P/21/0225 - ALDI MERTHYR TYDFIL EXTENSION - RESPONSE TO NRW COMMENTS

Further to comments from Natural Resources Wales regarding the above proposal, contained within their letter report reference CAS-157378-J9X8, we write to respond as follows.

CAR PARK AND STORE EXTENSION
PLYMOUTH STREET
MERTHYR TYDFIL

PROPOSED LEVELS
FLOOD ANALYSIS

It should be noted that since the proposal is for an extension to an existing building, and no change of use or floor level is proposed, there is effectively no significant change to the situation that would occur on site should an extreme flood event occur.

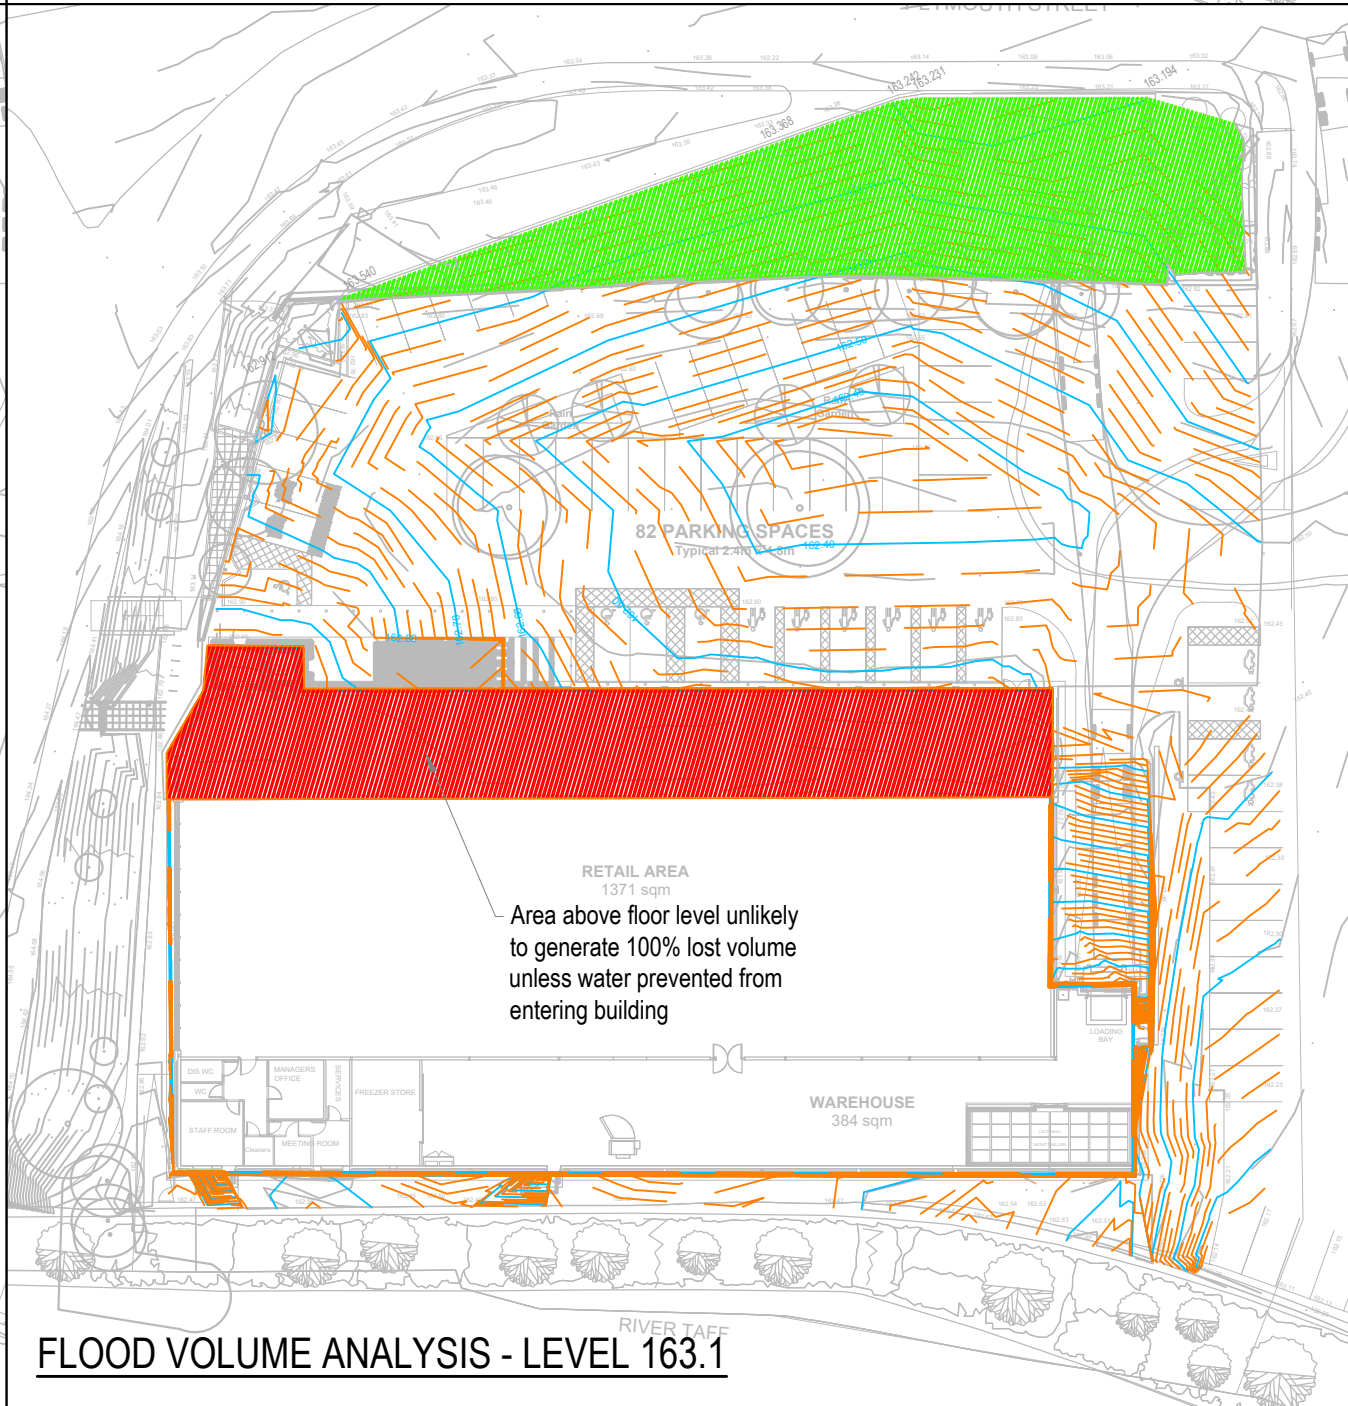
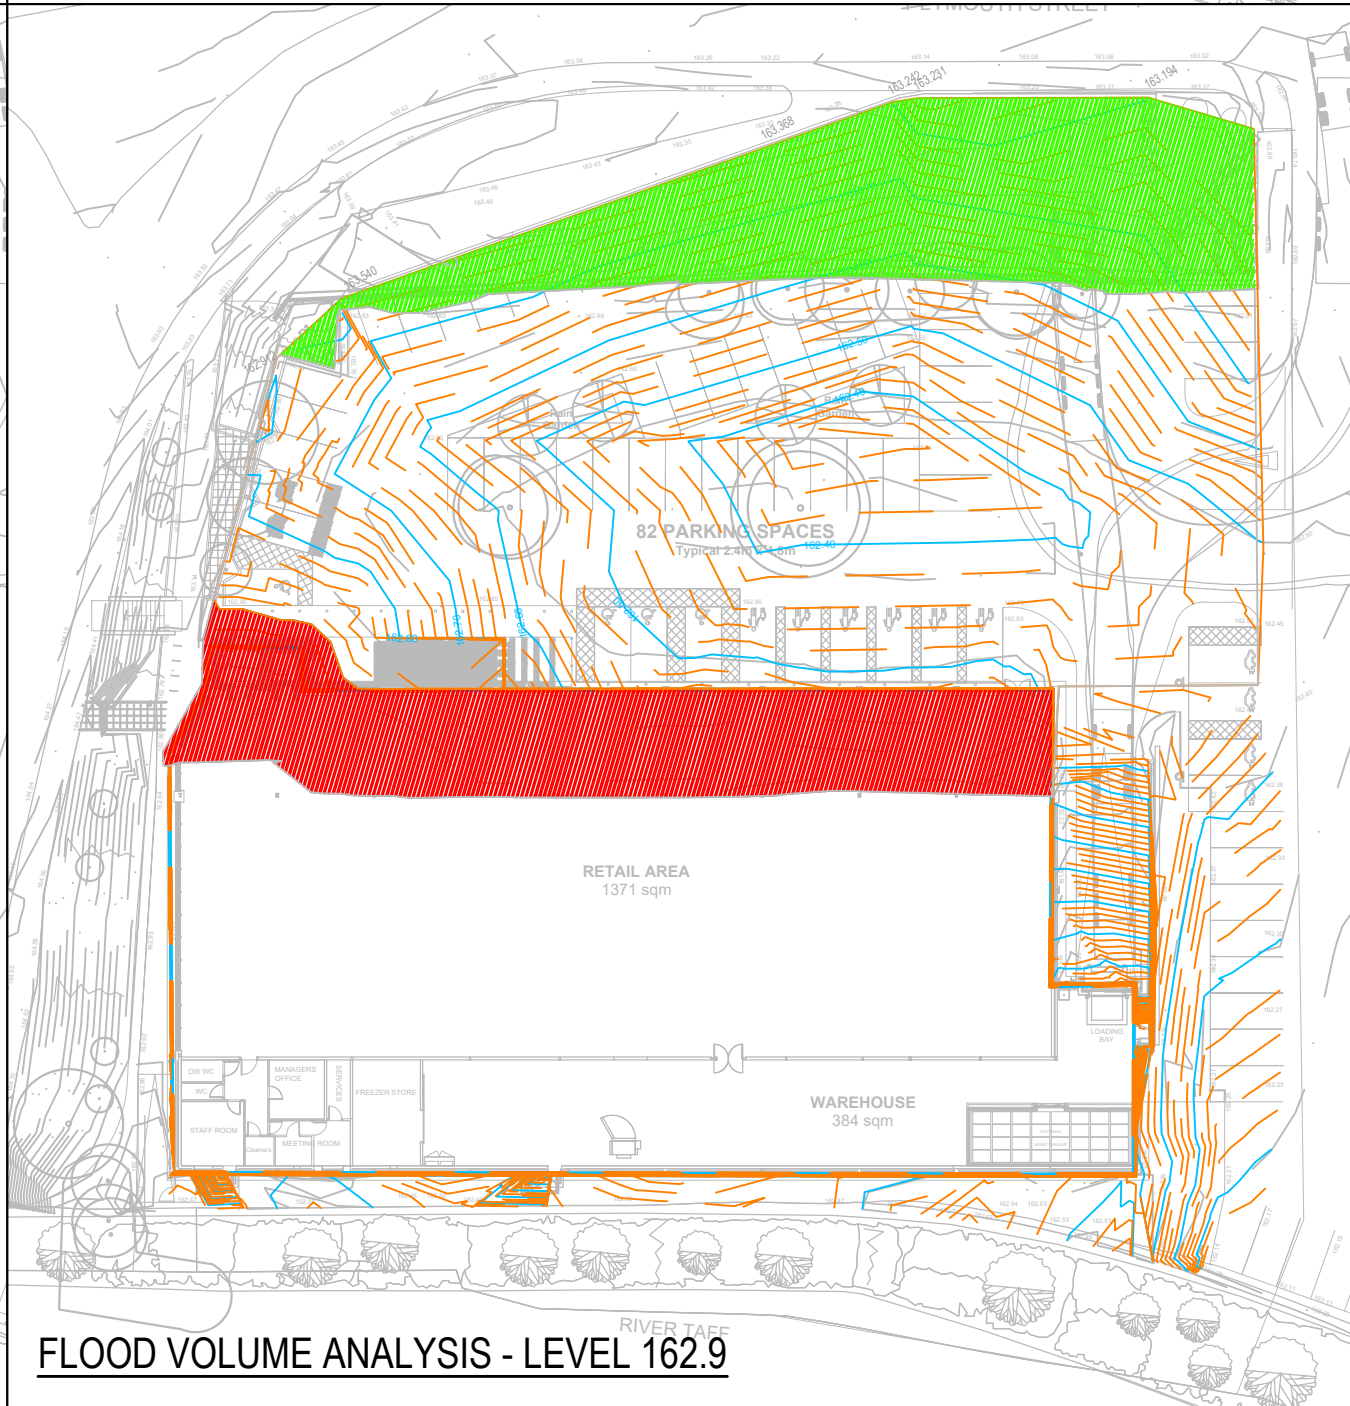
Beyond this, the entire site is likely to be inundated during the 1 in 1000-year event, since it is within the area shown as being affected on the FRAW map. It is therefore important to review flood volumes during such an event. A level-for-level analysis has therefore been carried out, as shown in sketch 0001 revision C enclosed.

0.1 metre depth "slice"	Flood plain loss (m²)	Flood plain gain (m²)	Difference (m²)
162.20	Approximate 1 in 100-year (1% AEP) flood level		
162.3 - 162.4	53.7	113.7	+60.0
162.4 - 162.5	62.7	130.5	+67.8
162.5 - 162.6	156.4	157.2	+0.8
162.6 - 162.7	284.4	294.6	+10.2
162.7 - 162.8	392.7	480.7	+88.0
162.8 - 162.9	431.8	515.3	+83.5
162.9 - 163.0	438.3	488.6	+50.3
162.95	Building floor level		
163.0 - 163.1	438.3*	478.0	+39.7*
163.1 - 163.2	438.3*	465.9	+27.6*
163.2 - 163.3	438.3*	414.1	-24.2*
163.3 - 163.4	438.3*	326.9	-111.4*
163.4 - 163.5	438.3*	166.6	-271.7*
163.5 - 163.6	438.3*	49.6	-388.7*
163.70	Approximate 1 in 1000-year (0.1% AEP) flood level		
*based on no water entry into building

It is therefore possible to increase flood volume storage within the site for all flood levels up to the building floor level, and to a depth of 250mm above the floor level.

Beyond this level, without any water entering the building, the proposed development would displace flood volume – this is because there is a decreasing area of the existing site area that can be lowered, to offset the additional building area.

It is therefore proposed not to exclude water from the building for flood events that may exceed the floor level – this is particularly important as since the proposed development is for an extension to an existing building, it will not be practicable to develop a water exclusion strategy for higher level flood events, since the existing structure will not be designed to withstand the higher head of water.

As such floodwater will enter the building and not be displaced by the proposed extension. The anticipated depth of internal flooding during the 1 in 1000-year event is approximately 750mm. The building should therefore be evacuated in the event of a flood warning being issued – as mentioned in the original FCS the store does lie within a Flood Warning Area. A flood warning and evacuation plan should be developed, if one does not currently exist for the store.
